# Access Compliance Report

## Public Rights-of-Way

### (Pedestrian Signals)

Intersection ID: N/A	Main Street:	Cross Street: N/A	Location: N/A
ADA ID: 52CC67404976	Signal Type: One Push Button-Non APS	Overall Compliance: No	Severity Score: BTN 1: N/A BTN 2: N/A No BTN: N/A
Codes/Mitigation Info/Possible Solution		Field Measurements/Component Compliance

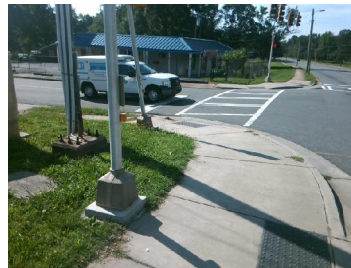
Surveyor Notes: TEXT HT 1/2

PROW/ADA: R410.6, TMUTCD 4e.08, R406.2

Possible Solutions: Replace Signal Push Button With APS Button on New Post. Remove & Replace Sign.
